**Addendum No. 1**  
**April 27, 2018**

Project: Convention Center Building Improvements – Kitchen Remodel  
Sioux Falls, South Dakota  
#2760

Bid Request No.: 18-1057  
CIP No.: 13005

Architect: Architecture Incorporated

DRAWING **SD-1**

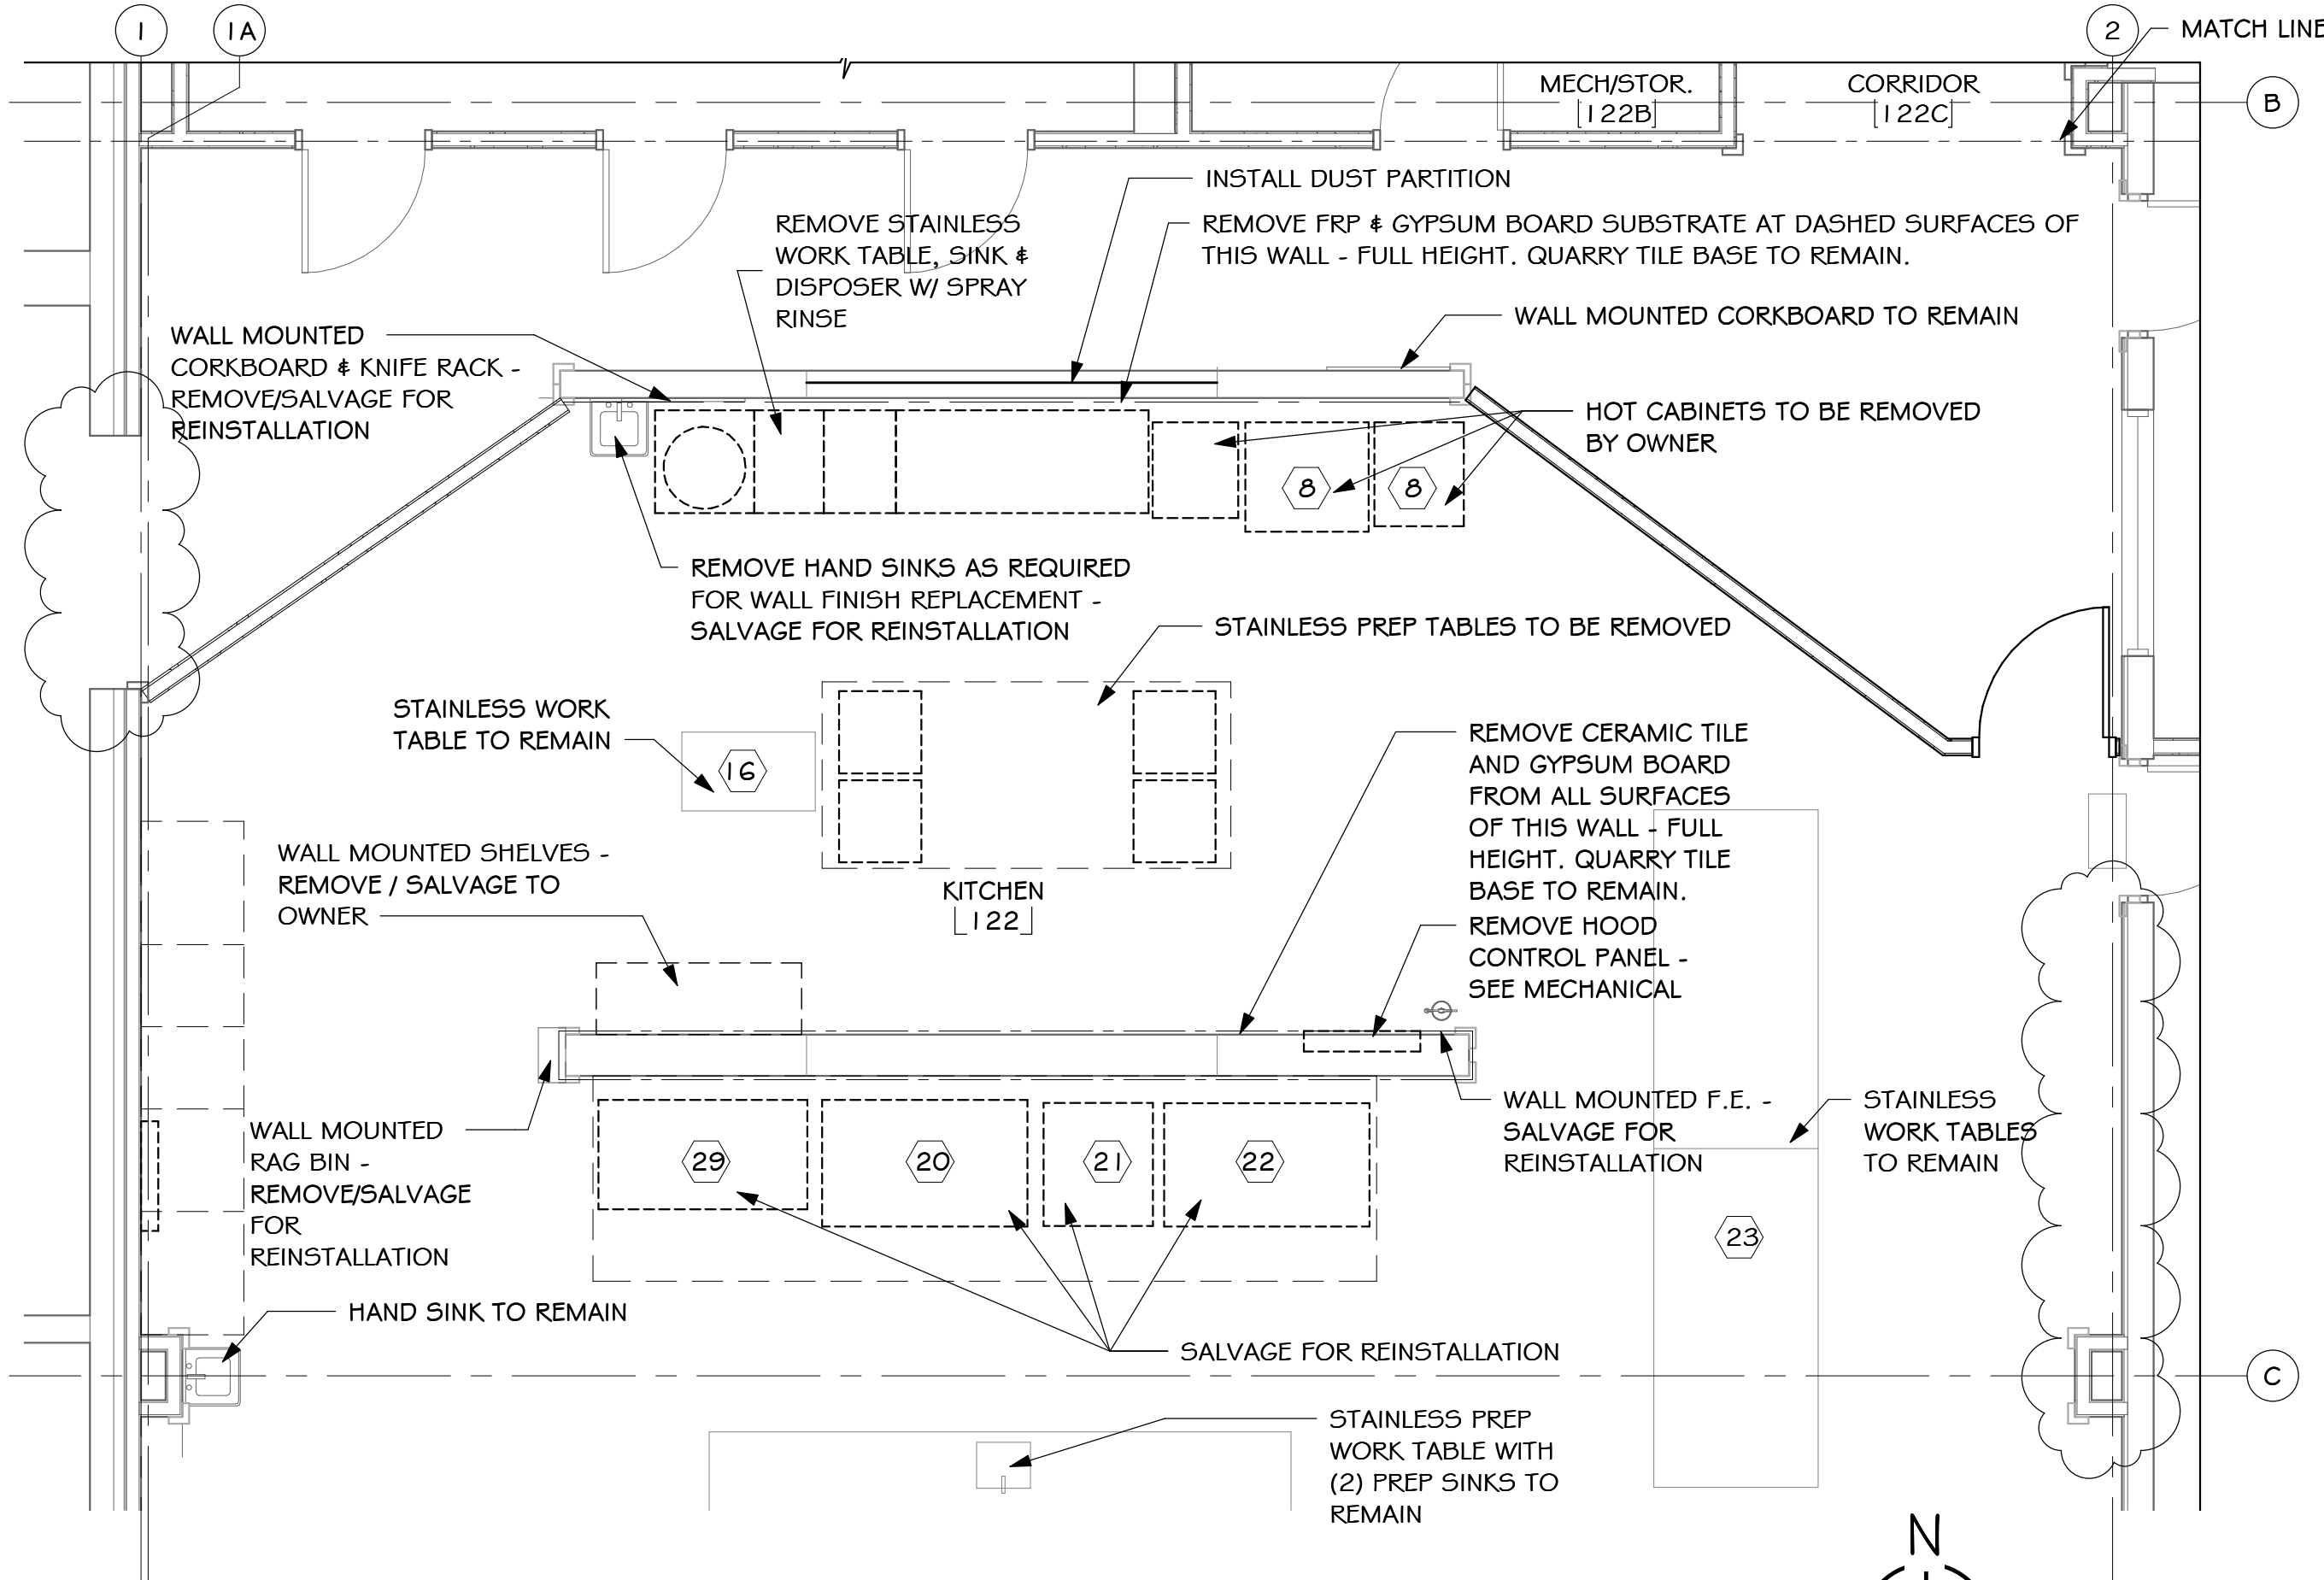
- 1) GENERAL
  - a) Minutes from the Pre-Bid Conference held on Tuesday, April 24, 2018 are attached to the end of this addendum.
  - b) Elevation of roof deck above kitchen varies from 18'-4" a.f.f. at the west (Grid 1) to 19'-4" a.f.f. at the east (Grid 2).
- 2) SPECIFICATION SECTION 078100 – APPLIED FIREPROOFING
  - a) Part 2.2.A – Sprayed Fire-Resistive Material can be either U.L. #P825 or #P826.
- 3) DRAWING SHEET 4.00 – DEMO FLOOR PLANS
  - a) Partial Floor Plan – Demolition – Omit heavy dashed lines indicating removal of FRP at east wall (from column surround at grid 'C' north to door jamb) and above opening to dry storage at west wall. FRP at these locations to remain. See attached SD-1.
- 4) DRAWING SHEET 5.10 – ROOF PLAN AND WALL SECTIONS
